Product Change Notification / SYST-27OHRV327

ERRATA - PIC18(L)F24/25K42 Silicon Errata and Data Sheet Clarification

PIC18(L)F24/25K42 Silicon Errata and Data Sheet Clarification

Figure 44-5 Clock Timing

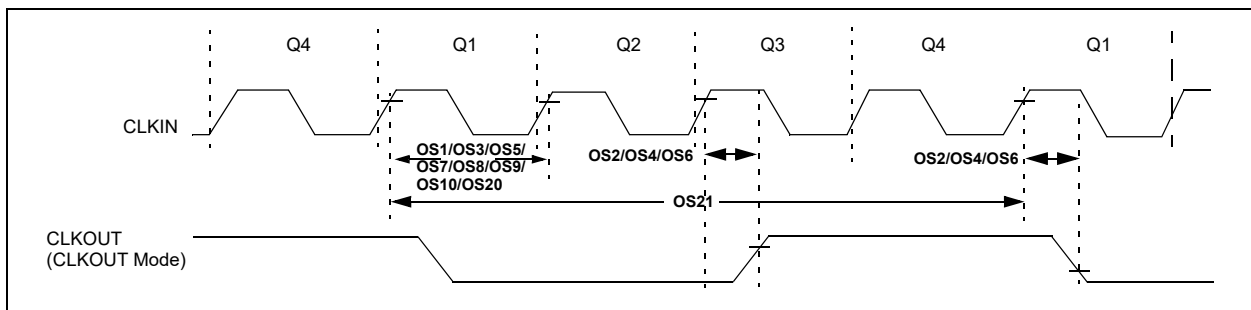
Figure 44-5 incorrectly shows the location of parameters OS1, OS2, OS3, OS4, OS5, OS6, OS7, OS8, OS9, OS10, OS20 and OS21. The correct location for the above-mentioned parameters is depicted in the following figure.
